**Joint Meeting of Experts on the Regulations annexed to the
European Agreement concerning the International Carriage
of Dangerous Goods by Inland Waterways (ADN)
(ADN Safety Committee)**

Geneva, 22-26 January 2018

**Proposal for the implementation of the modified concept for
explosion protection on board inland waterway vessels**

**Transmitted by the Central Commission for the Navigation of the
Rhine (CCNR)*, ****

Classification of zones for tank vessels

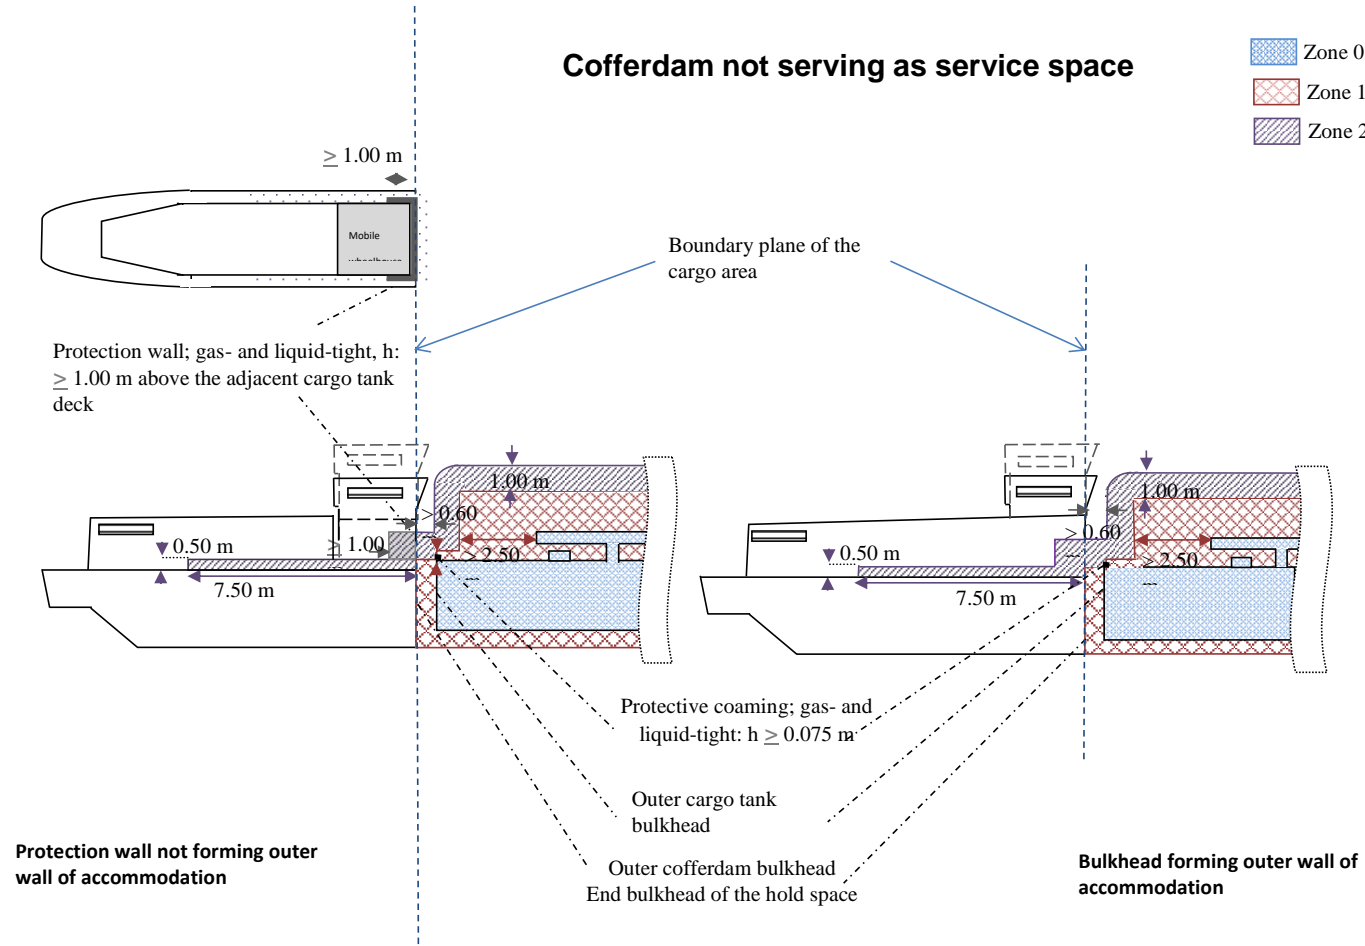
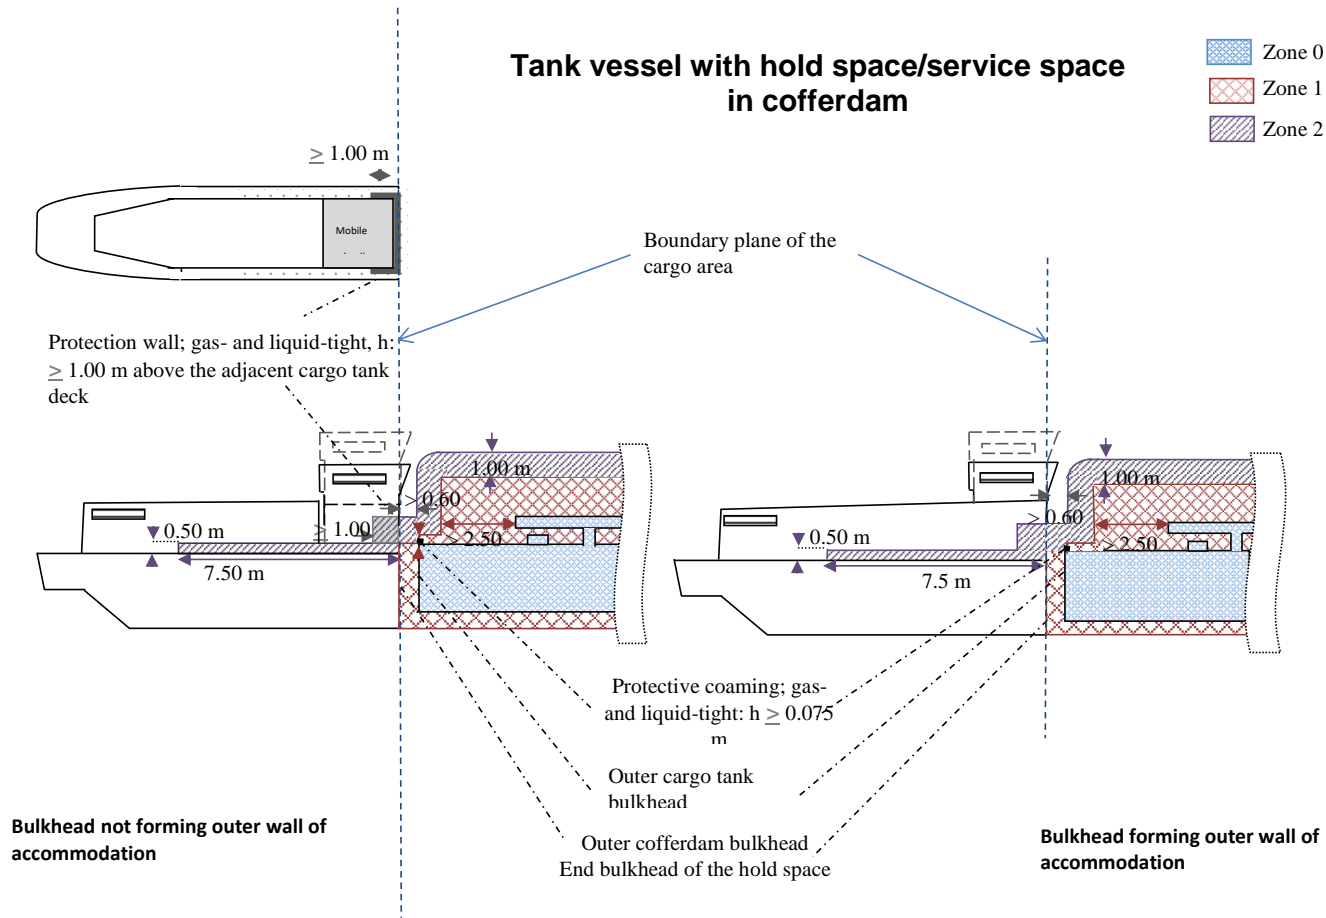
- All spaces located below deck in the cargo area not part of zone 0.
- Closed spaces on deck within the cargo area.
- The deck in the cargo area over the entire width of the vessel to the outer cofferdam bulkheads.
- Up to a distance of at least 1.60 m to the “boundary planes of the cargo area”, the height above the deck is 2.50 m, but at least 1.50 m above the highest piping carrying cargoes or cargo vapours.

If the ship is built with hold spaces or a cofferdam/part of a cofferdam is arranged as a service space, the adjacent height (fore and aft) to the “boundary plane of the cargo area” is 1.00 m above deck (see diagram).

- On the deck in the cargo area, a zone extending 1.00 m upwards and joining zone 1 longitudinally.
- On the fore deck and the aft deck, an area 7.50 m in length across the entire width of the vessel and adjacent to the “boundary plane of the cargo area”. Between the lateral side of the vessel and the protection wall, the length and height of this area equals the dimensions of the lateral side of the protection wall. Elsewhere, the height in zone 2 is 0.50 m.
